PLANNING BOARD AGENDA FOR SEPTEMBER 22, 2026 - 7:00 PM

1. **Tuscan Village Master Development Site Plan** – Conceptual Discussion on revised master plan for Tuscan Village to include 120-key hotel, 392 apartments, 72 workforce housing units, medical office, general office, bank, and restaurant uses at 14-24 Tuscan Blvd, Map 107, Lot 12605. Continued from 7/28/2026.

TUSCAN VILLAGE MASTER PLAN UPDATE

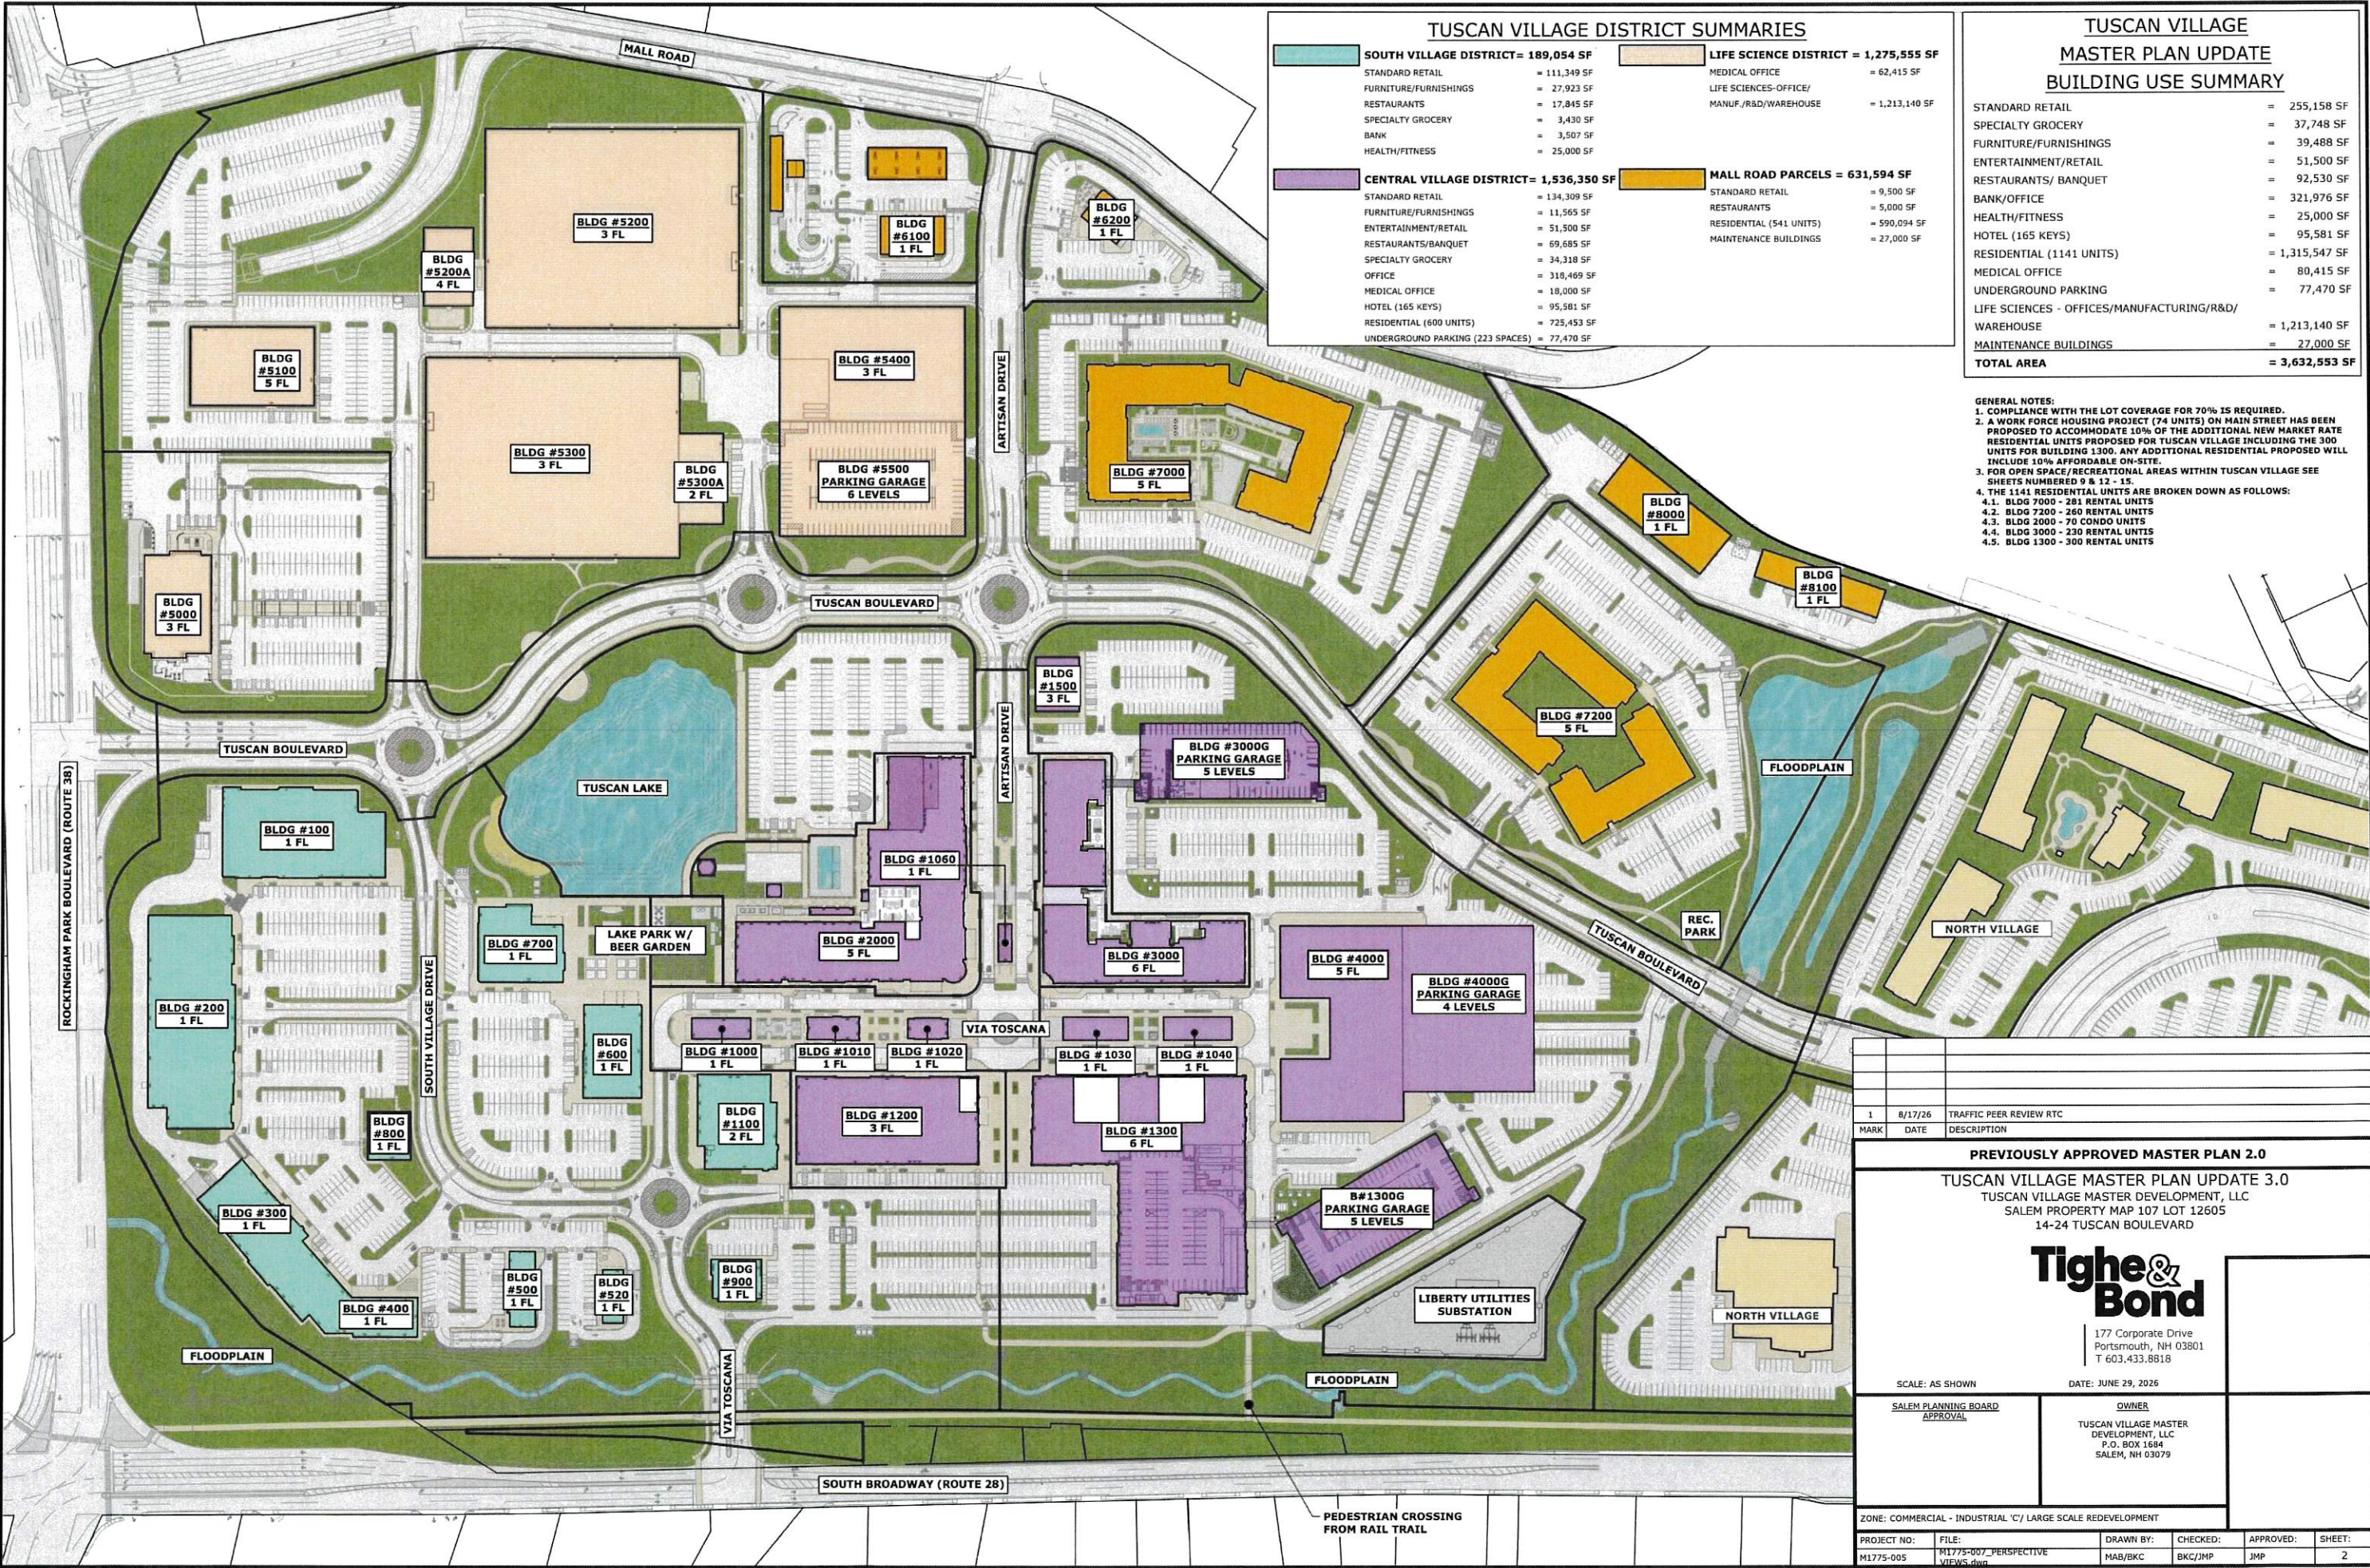
- Sheet 2 – Previously approved Master Plan 2.0
The tabulation in the upper right-hand corner of this Sheet does not add up to 3,632,553. It appears that the restaurant/banquet space should be changed from 87,530 to 92,530 sf.

Response: All these sheets have been updated accordingly. The sf areas in some of the districts have been updated based on changes of use in those areas. (i.e in the South Village District the restaurant in B 800 is now retail). The listed Restaurant/Banquet space listed on Sheet 2 has been adjusted to 92,350 sf such that the sum of all uses equals 3,652,553. The values within District Summary and Building Use Summary tables on Sheet 3 have been revised to be consistent with the tables on Sheet 5 for all districts. The GFA shown within the footprint of Building 5000 on Sheet 4 has been adjusted to 62,415 sf. The GFA shown within the footprint of Building 5000 on Sheet 6 has been adjusted to 62,415 sf. See attached updated Sheets 2-7.
